SERVICE INFORMATION

YS-005-09
Revision 2

Subject: Emerson Single Stage Furnace Control Boards – All Single Stage 33' & 40" Models
Control Board Part # (S1-03109166000/SAP#265901 & S1-03109167000/SAP# 265902)
Source 1 Kit Part # (S1-33109167000) (S1-37326083000) & (S1-43101972100)

York 50A56-243 Rework Labeling Procedure

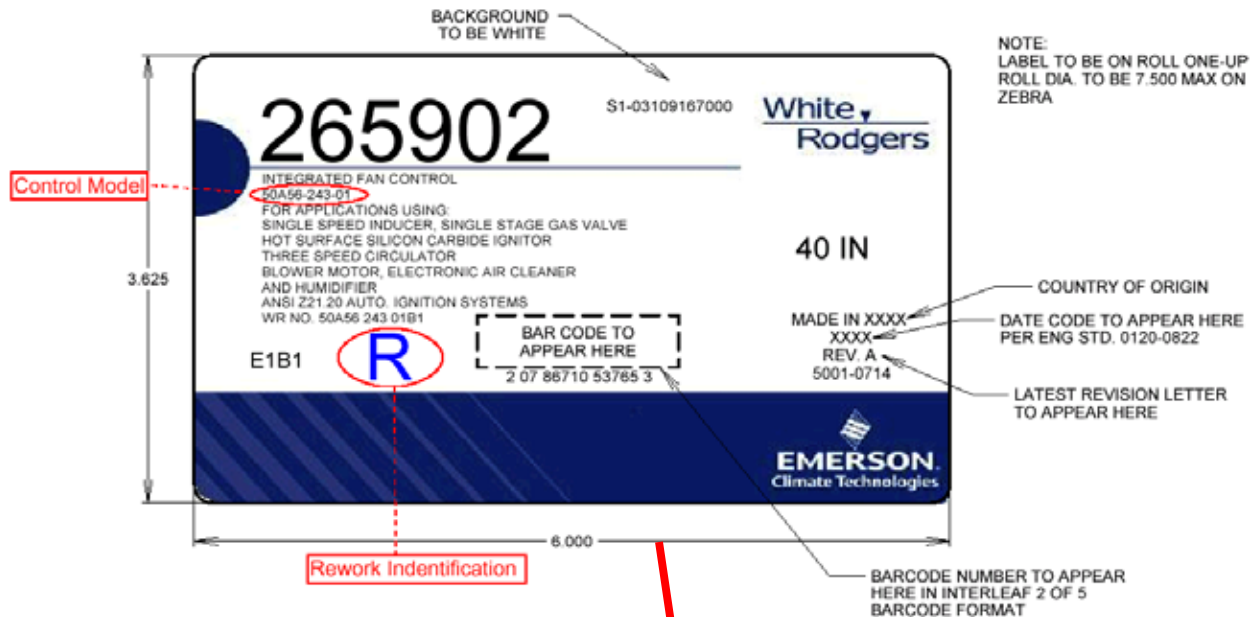
- 1) The new label will be marked with model number 50A56-243-01 and an “R” following the date code to identify it as a reworked control.

For repair parts, a “Green Circle” sticker on the carton, along with the bold capital “R” on the carton sticker will be a visual indication that the control in the carton was reworked.
